Staff Report
SP-26-0006

Request: Site Plan to construct a new 120,000 sq.ft., 2-story medical office building with 600 parking stalls in a single phase on Lot LRK, LLC-3 of the Leon R. Kleinpeter Property with associated off-site regional stormwater management facilities

ST. GEORGE PLANNING COMMISSION
 SITE PLAN SUBMITTAL

PROJECT NUMBER:
01002

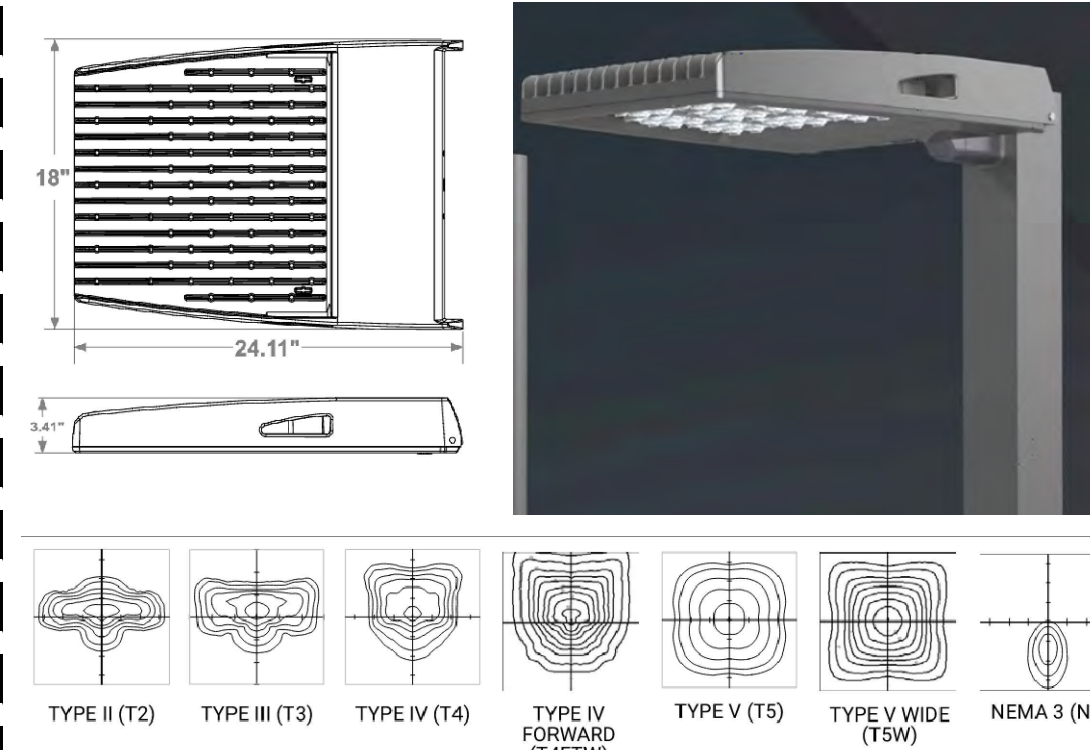
8. After review of the site plan access and circulation, the City's Engineering Department recommends the following:
 - To avoid unnecessary conflict points on Pecue Lane (closest to the signal at Rieger Road), only one (1) access drive shall be provided on Pecue Lane, as a shared access drive with adjacent Lot LRK, LLC-4.

- The applicant also indicated that access points are to be dedicated to staff only, delivery/ambulance, and visitor-only entrances in response to engineering comments. These restrictions with any type of access gates on this property would also create potential queuing on Pecue Lane. Any restrictions shall be shown on plans and reviewed prior to issuing permits.

- The proposed access connection to Rieger Road is acceptable, with the understanding that it may be modified or relocated in the future to facilitate a shared access arrangement with adjacent future developments, if determined necessary by the City.

- (1) Provide plans in compliance with the City Engineering Department’s recommendations for roadway access, including limiting access to the one (1) shared access drive on Pecue Lane and modifying the site layout as necessary to accommodate the revised access configuration;
